World Forum for Harmonization of Vehicle Regulations

Proposal for Supplement 6 to the 02 series of amendments to UN Regulation No. 129 (Enhanced Child Restraint Systems)

Submitted by the Working Party on Passive Safety *

Figure 2
ECRS Measurement Device - Side and Front View of the measuring device

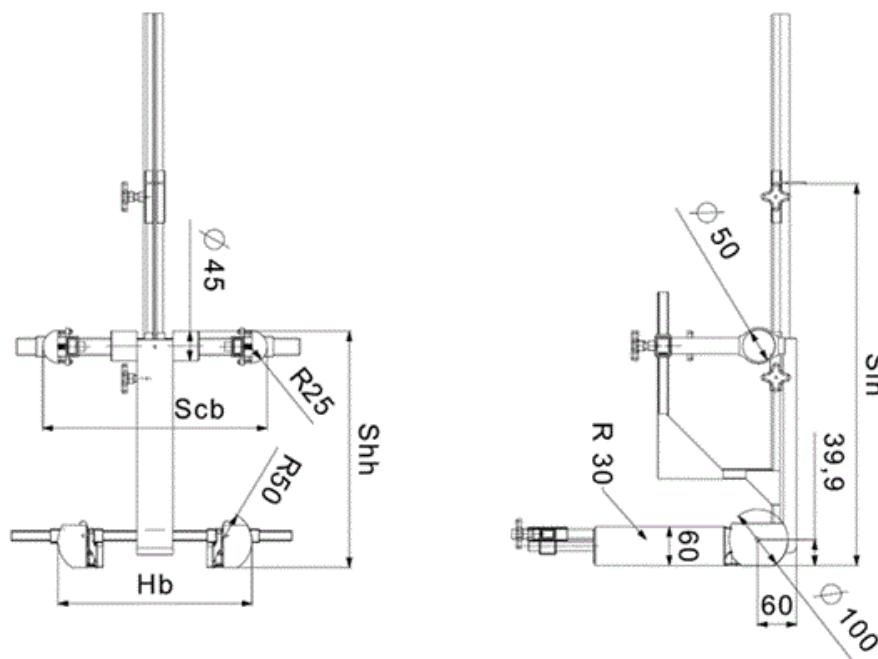
Annex 18, amend to read:

Geometrical dimensions of Enhanced Child Restraint Systems

For integral or non-integral ECRS the device shown in Annex 18, Figure 2 shall be used.

The mass of the devices described in Figure 2 and Figure 3 shall be 10 kg +/- 1 kg.

All measurements shall be taken with the device base in contact with the seat pan of the ECRS and the device backrest in contact with the backrest of the ECRS. All lateral dimensions shall be measured under a contact force of 50 N with the devices described in Figure 2 and Figure 3 of this annex.
